REVIEW
AIR QUALITY IMPACT ASSESSMENT
MT OWEN CONTINUED OPERATIONS
PROJECT

NSW Department of Planning & Environment

29 April 2016

Peer Review

Figure 11: Distribution of modelled emissions, Project Year 1.

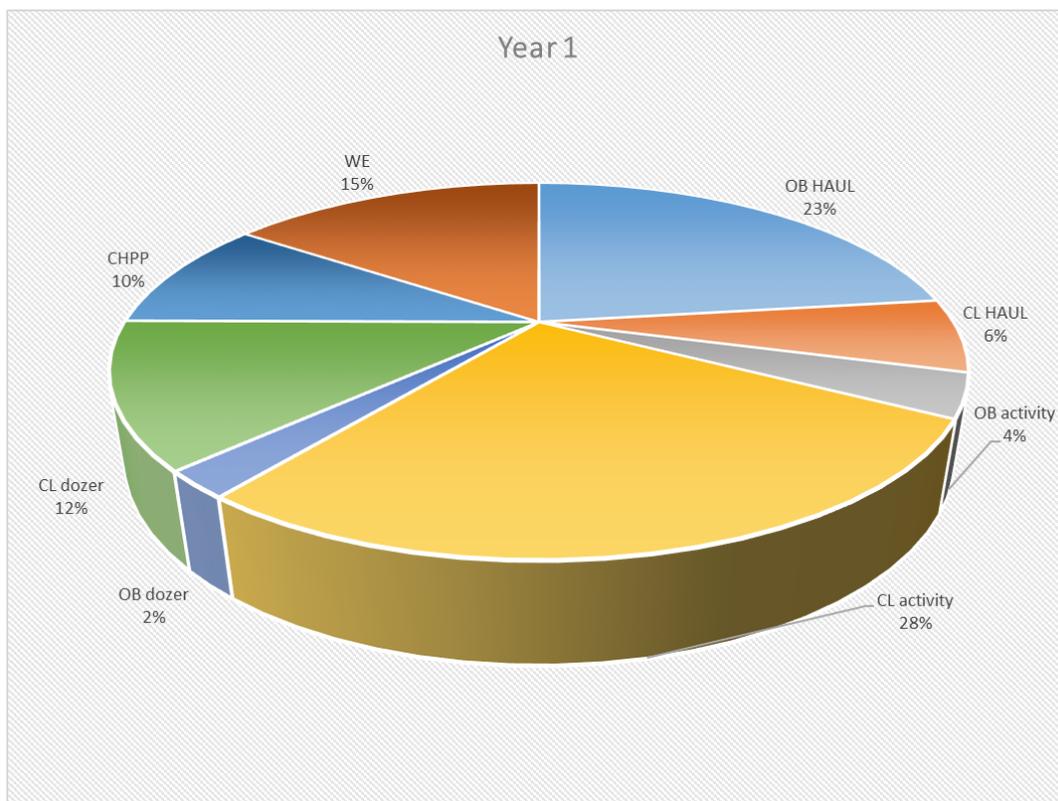
Figure 11 shows a breakdown of the dust sources for the Project as assessed in Year 1. The figure indicates that the quantity of emissions in the inventory for some of the key sources of dust from the Project appear to be significantly different to what is likely to occur in practice.

For example in Year 1, Overburden Activity accounts for only 4% of the total emissions and Coal Activity, including dozers on coal, makes up 40% of total emissions. Relative to most other mines of a similar nature, these key sources of dust emissions from the Project appear to be many times too low and too high respectively.

As emissions from overburden tend to occur in the more elevated areas of the mine with more scope to be carried off by the wind than coal activities which tend to occur at the base of the pit, and at stockpiles generally located further from receptors, this may skew the modelling results and may lead to an underestimation of the potential impacts.

Figure 12: Pollution roses for period modelled for SX10 (left) and SX9 (right) dust levels using SX13 weather data

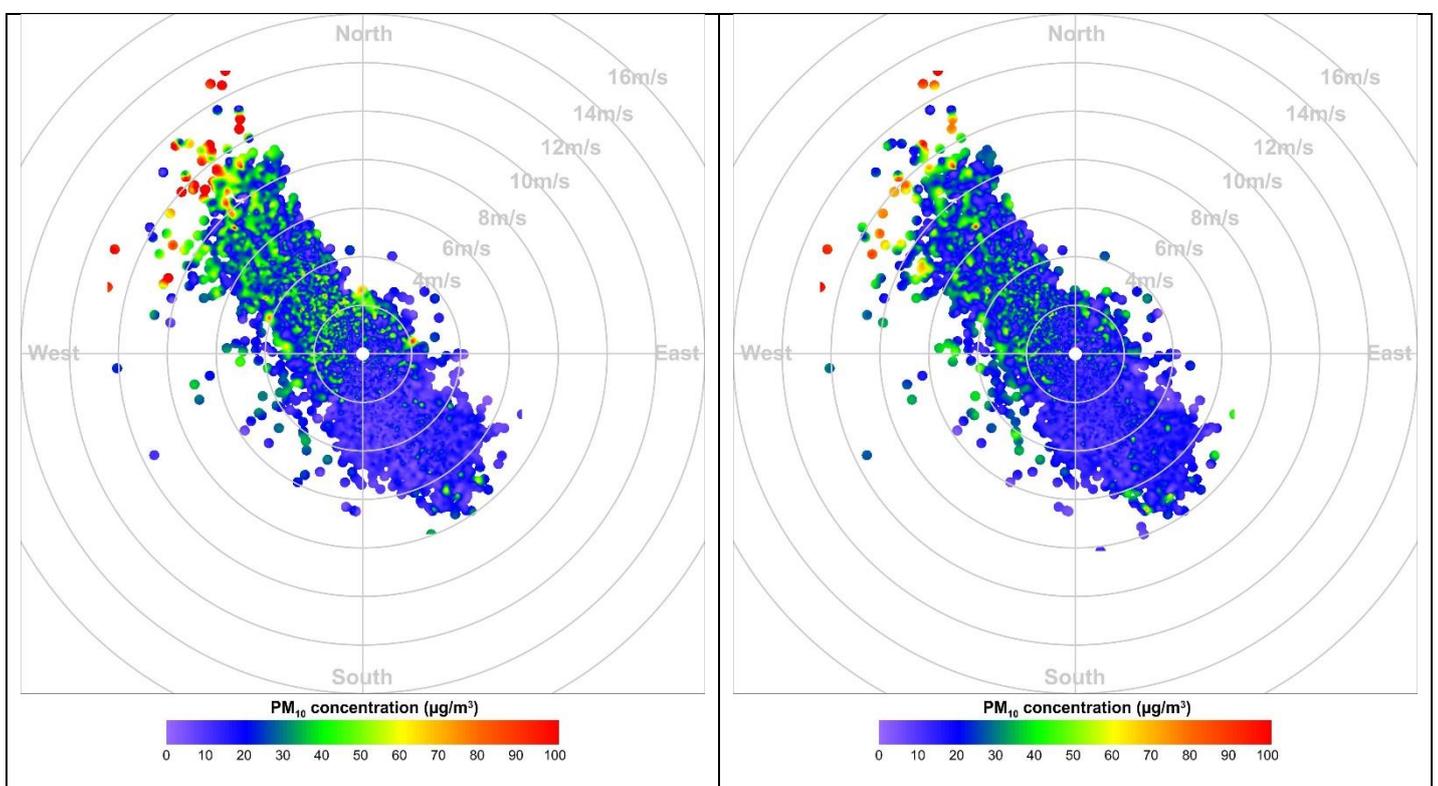
The proponent did not provide pollution roses for the baseline year (chosen modelling period). This is provided by the review in **Figure 12**.

The pollution roses for the modelling period, and also the measured data at SX9 and SX10 show that the dust levels from the northwest quadrant are close to double (approximately 160% to 220%) those from the southeast quadrant on an annual average basis. As a large part of this would be from mining dust, the proponent's predictions in regard to the scale of the contributions from the various sources to dust levels appear to be in conflict with the actual situation.
